DEVELOPMENT REVIEW BOARD REPORT

Dual Drive-Thru Restaurants Pima Road 40-DR-2021	Request for approval of a site plan, landscape plan, and building elevations for two new drive-through restaurants on a +/- 1.5-acre site.
---	--

40-DR-2021

SP-1

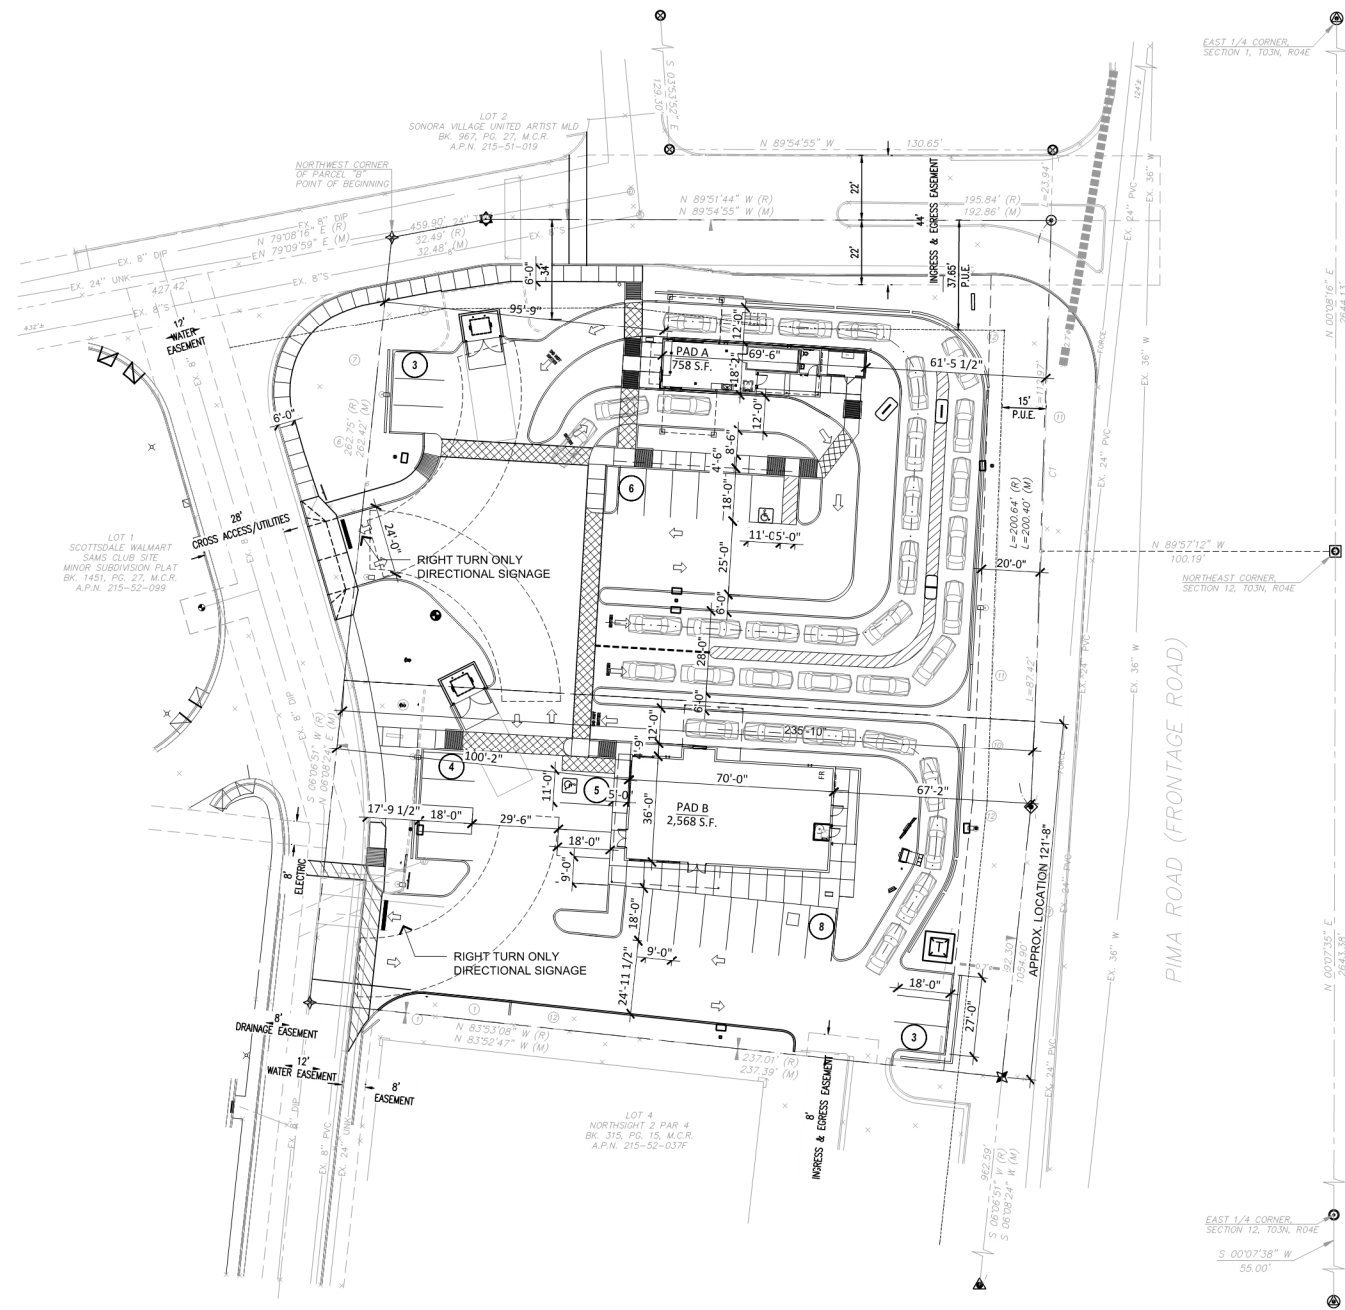
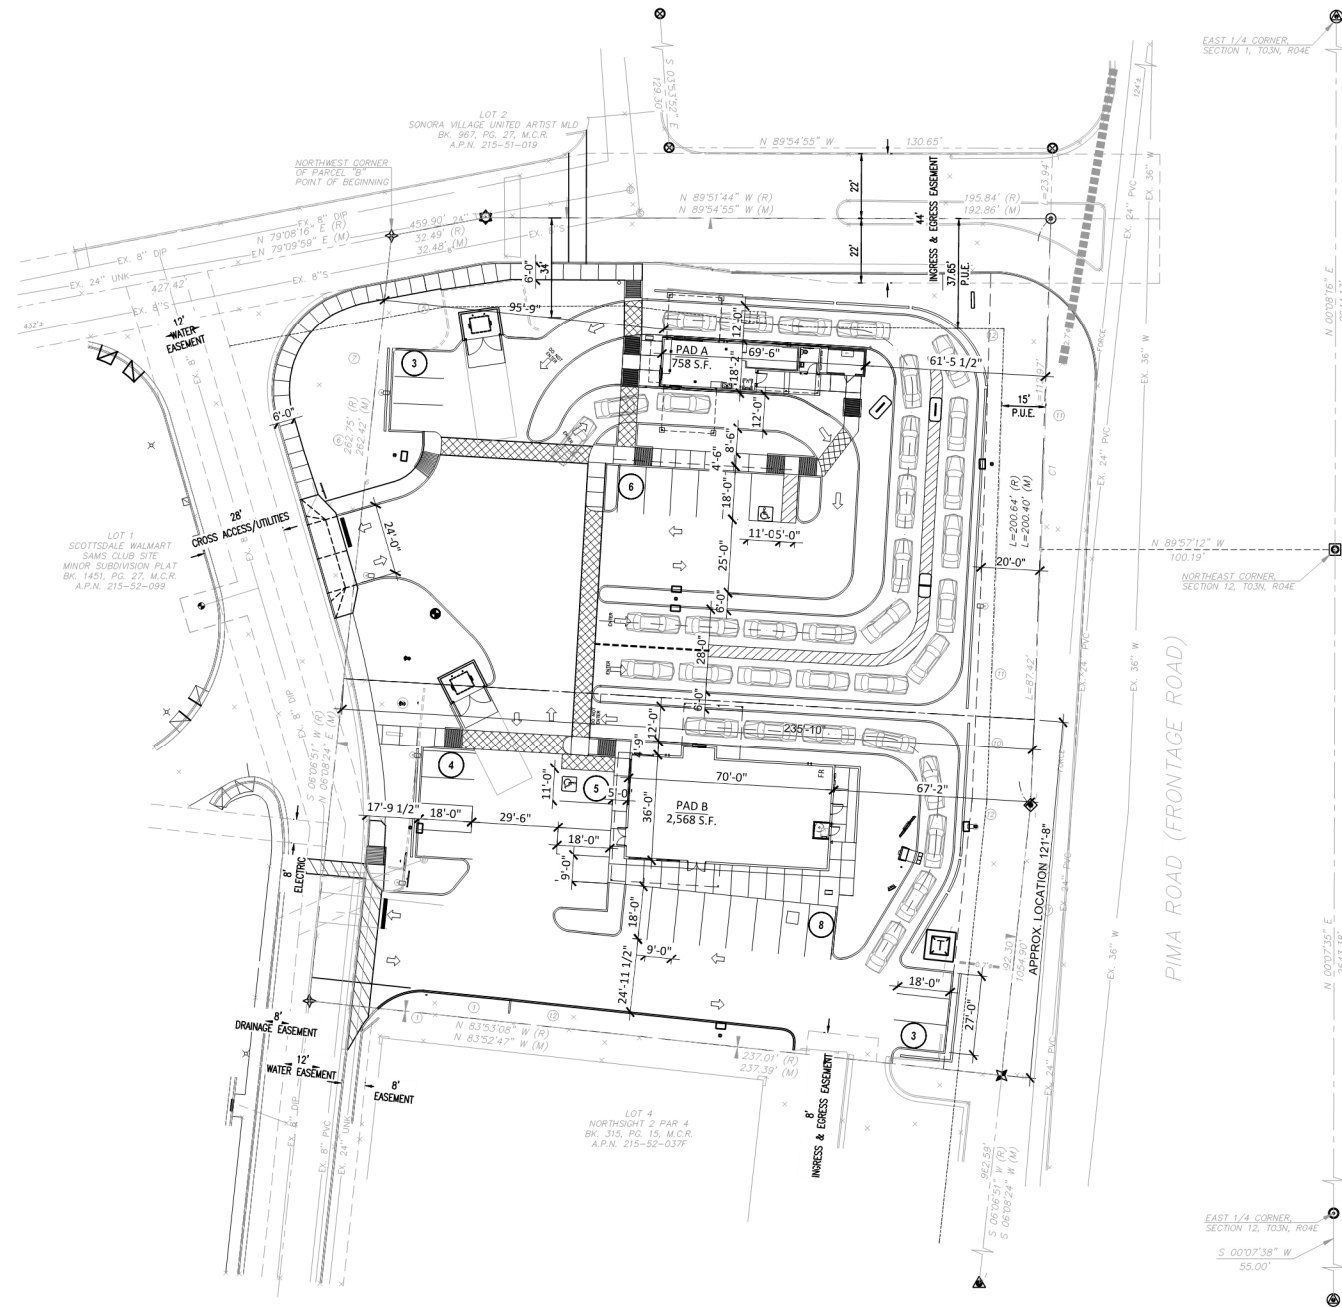
The Board was also concerned about the additional traffic the two new drive-through restaurants would bring to the already busy commercial shopping center. Staff explained the drive-through restaurants are an allowed land use in the Highway Commercial zoning district, but suggested the applicant complete a queueing analysis for review. Transportation staff has reviewed and approved the provided queueing analysis and finds the proposed layout maximizes the queueing available on site, exceeds DSPM requirements, and should minimize any impacts on the surrounding private street network. Per the Board's request the applicant also provided a site plan with clear traffic arrows to help clarify internal site circulation.

- *Staff finds that there are two driveways along the western boundary that lead to the internal drive aisle, one driveway entrance per PAD. Shared access with the southern neighbor is maintained and there is no access along the Loop 101 Freeway frontage road. Transportation staff had some concerns regarding the counter flow secondary drive-through on the northern parcel, but the applicant will provide signage and directional marking to help direct traffic. The site plan provides sidewalk connections from both PAD entrances to each other and to the existing internal pedestrian sidewalk. Additionally, the applicant agreed to extend the existing pedestrian sidewalk north and east along the internal drive aisle to connect with other sidewalks within the center for enhanced pedestrian circulation.*

5. All drive aisles that are fire lanes shall have a width of twenty-four (24) feet.
6. All drive-thru lanes shall provide a minimum of 120 feet of queuing distance.
7. With final plans, the drive-through lane striping shall be replaced with a raised concrete divider to help guide traffic.
8. Prior to issuance of any building permit for the development project, the property owner shall submit plans and receive approval to construct all refuse enclosures in conformance with staff approved DRB site plan sheet SP-1, by RKAA, dated 03/14/2022.
